RESPONSE TO REQUEST FOR ADDITIONAL INFORMATION

APR1400 Design Certification

RAI No.: 77-7991
SRP Section: 09.01.03 – Spent Fuel Pool Cooling and Cleanup System
Application Section: 9.1.3
Date of RAI Issue: 07/15/2015

A

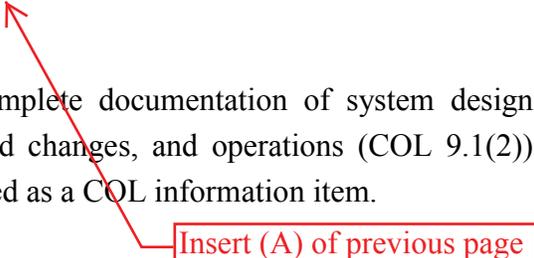
The staff evaluated the proposed COL information item and determined that additional information is needed. The proposed COL information item does not specify which detection equipment or contamination control programs need to be provided for an operational procedure and maintenance program. The COL information item also lacks the inspection interval for the maintenance program (for example, DCD Tier 2, Section 9.1.2.2.2 states that the SFP liner leakage monitoring system is monitored weekly and inspected every refueling).

The applicant is requested to update COL 9.1(1) to identify the detection equipment and contamination control programs that the COL applicant needs to create.

The COL applicant is to provide operational procedures and maintenance programs for the inspection, calibration, testing, and maintenance of the SFP leak detection provision (sight glasses), pool water temperature, pool water level, SFP area radiation monitor, and the SFP steel liner. The COL applicant is also to provide the inspection interval for the maintenance program. In addition, the COL applicant is to provide operational procedures and maintenance programs for the design features implemented for SFP contamination control, including heat exchanger seals, epoxy coating, and SFP filters and demineralizers. The contamination control procedures and programs can be integrated into an overall plant-wide RG 4.21 program following the guidance from NEI 08-08A.
